Site Plan Review Committee (SPRC)
Staff Report for
Walgreen's Site – 3130 Langston Boulevard (SP #481)

SUMMARY: The applicant, Rooney Properties, LLC, proposes to redevelop the Walgreen's site located at 3130 Langston Boulevard and construct a new multifamily residential building with ground floor retail space.

Figure 13: Building Section (proposed mezzanine outlined in red)

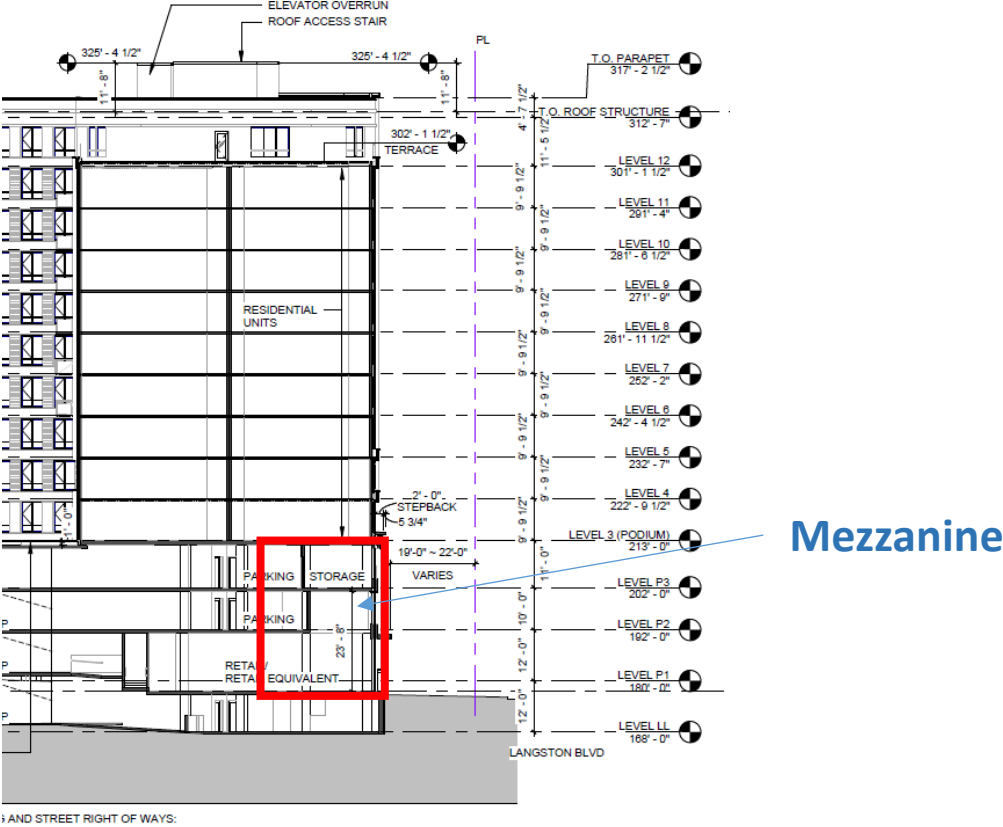
The Applicant proposes a 12/13-story building, with a 3-story podium base, and an L-shaped tower that engages both the I-66 and Langston Boulevard frontages that includes 10 stories. As shown in the plan section below, a portion of Level P2 within the podium is a ‘mezzanine’ and open to below for a portion of the retail and lobby space. The overall building height in feet is 136 feet, which is consistent with the overall height in feet prescribed by the Area Plan.

Figure 14: Proposed Building Stepbacks

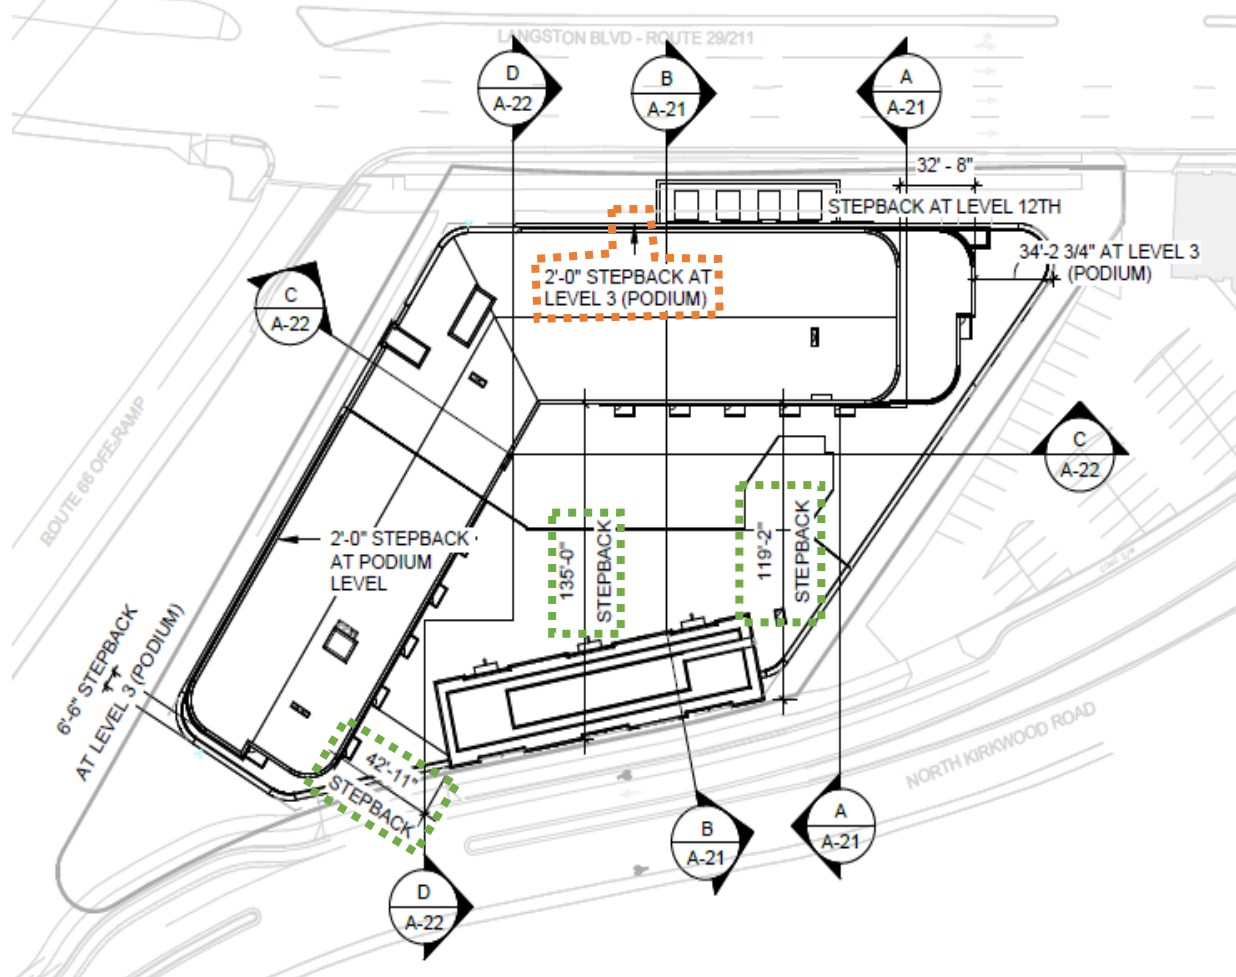
For building form, the Area Plan calls for upper story stepbacks from the podium in order to allow daylight to the streetscape and public spaces and to offer terraces for vegetation, green roofs, and outdoor occupiable space. Specifically for this site, a 10-foot stepback above the podium is called for on the façade adjacent to Langston Boulevard and a 35-foot stepback is called for on the façade adjacent to Kirkwood Road. While the Applicant does propose two significant stepbacks on the third and 12th levels on the northeast corner of the building for vegetated terraces, the remainder of the Langston Boulevard façade steps back only 2 feet on level 3 between the podium and tower. On Kirkwood Road, the tower steps back significantly from the podium in excess of the minimum stepback of 35 feet, which is in conformance with the Area Plan and helps to create a human and pedestrian scale along the Kirkwood Road frontage.

Figure 15: Site Access

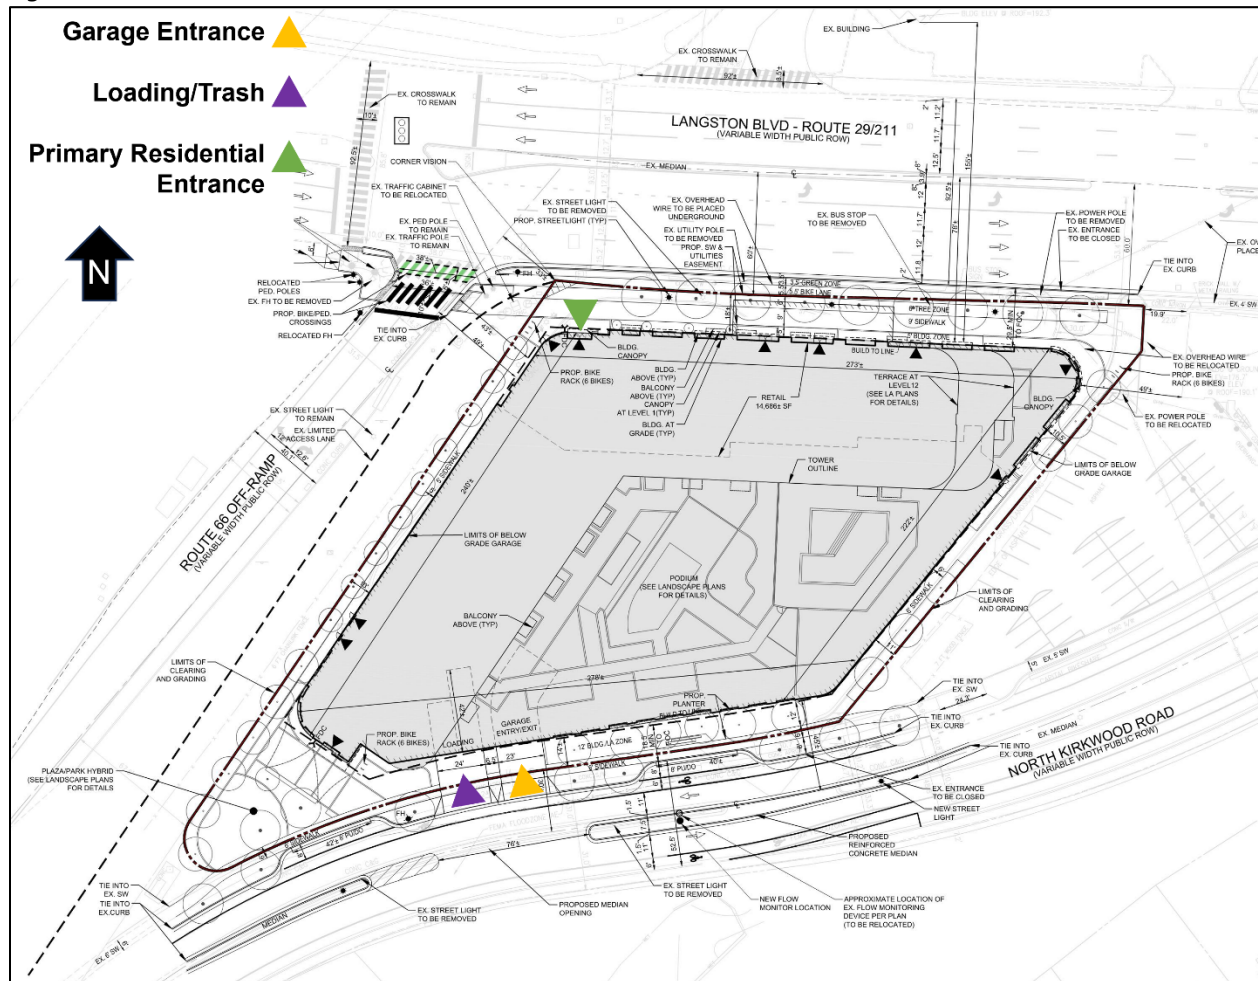
spaces, and utilize screening to minimize visual and noise impacts. The applicant proposes 360 total parking spaces, located in a partially below-grade garage with access from North Kirkwood Road. The garage includes four floors: one below-grade parking level, an at-grade parking level, and two above-grade parking levels. The applicant allocates the parking spaces as 326 residential parking spaces at a parking ratio of 1.05 spaces per unit, and 34 retail parking spaces at the required ratio of 1 space per 250 square feet of retail space. The applicant proposes two loading bays, which will be shared between the residential and retail uses, and be located adjacent to the garage entrance from North Kirkwood Road.

The site is bounded by Langston Boulevard, North Kirkwood Road, and the Interstate 66 off-ramp. The existing and proposed transportation facilities are further discussed in detail below. Staff continues to assess the proposal for consistency with County policies and guidelines.

Figure 18: Proposed Langston Boulevard Cross-Section (Facing East)

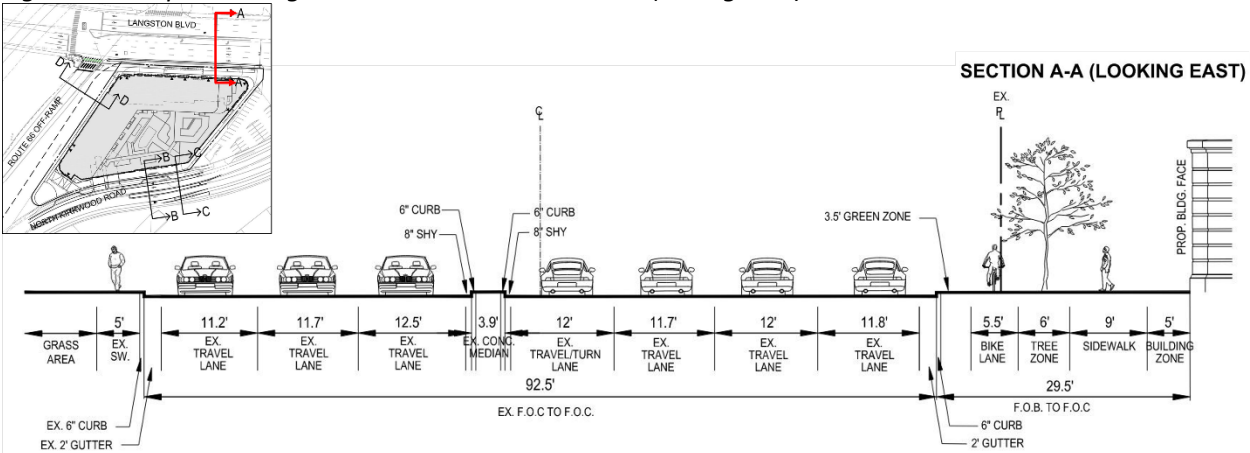
The applicant proposes to generally retain the existing Langston Boulevard street section, but to modify the streetscape along the site's frontage. For the street, the applicant proposes to reduce the outermost eastbound travel lane by approximately 1 foot to a 11.8-foot-width. The applicant proposes the reduced travel lane in order to increase the gutter pan from being 1.5-foot-wide to a 2-foot-wide VDOT-compliant width and to increase the streetscape width by 0.5 feet. For the streetscape, the applicant proposes an approximately 29.5-foot-wide streetscape consisting of a 3.5-foot-wide green zone for landscaping, a sidewalk-level 5.5-foot-wide bike lane, a 6-foot-wide tree zone, a 9-foot-wide sidewalk, and a 5-foot-wide shy zone. The applicant proposes to remove an existing driveway entrance from Langston Boulevard so that the site no longer has direct vehicle access to this street.

Figure 19: Proposed North Kirkwood Road Cross-Section (Facing Northeast)

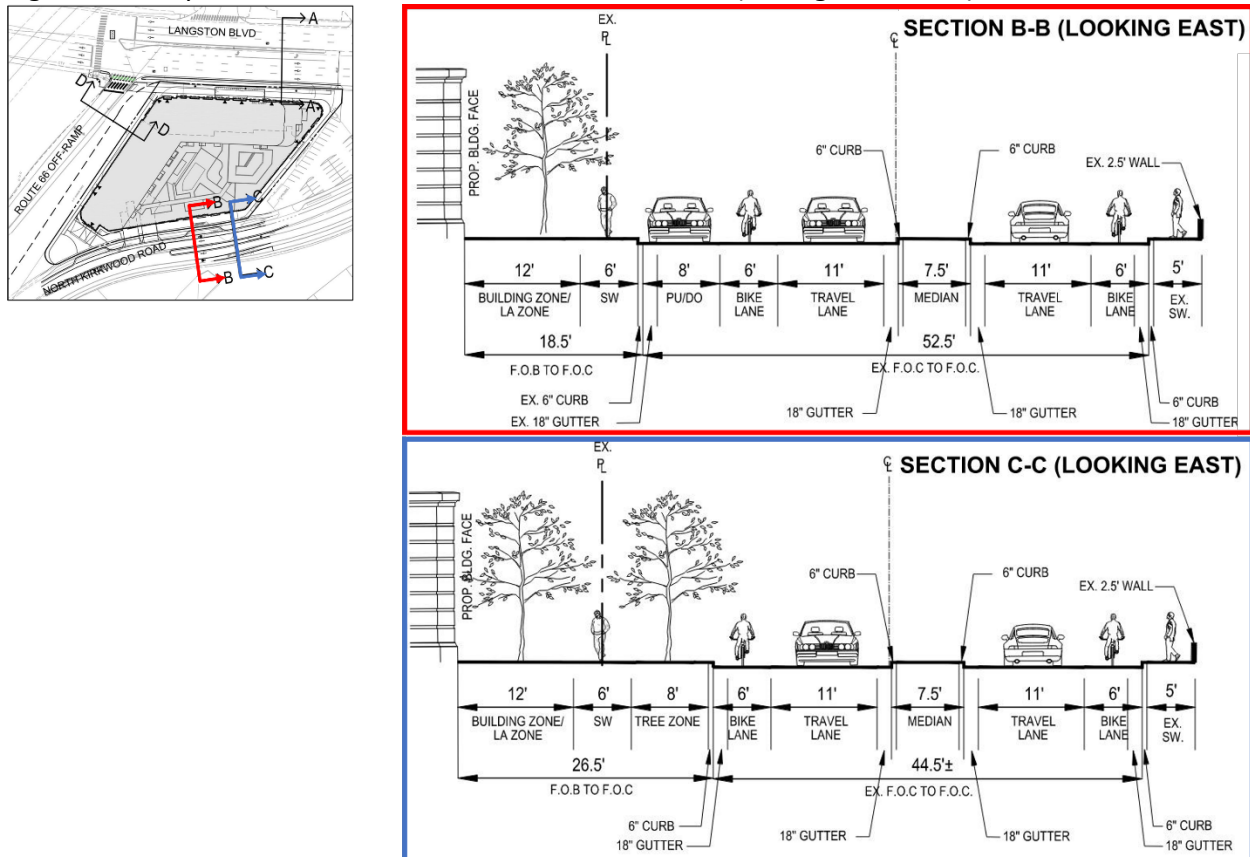
The applicant proposes changes to North Kirkwood Road to accommodate the new site access, but generally proposes to retain the existing street condition. The applicant proposes to close the eastern-most driveway entrance and the associated median break, reconfigure and widen the remaining driveway entrance to serve the proposed garage and loading/trash bay entrance, provide a new median break for this entrance, and widen a portion of the street to include an 8-foot-wide on-street parking lane for pick-up/drop-off activities on either side of the garage entrance. For the streetscape, the applicant proposes an approximately 26.5-foot-wide streetscape section consisting of an 8-foot-wide tree zone, 6-foot-wide sidewalk, and 12-foot-wide shy and landscaping zone. For the sections with the above-mentioned parking, the applicant proposes to remove the 8-foot-wide tree zone to allow space for the parking.
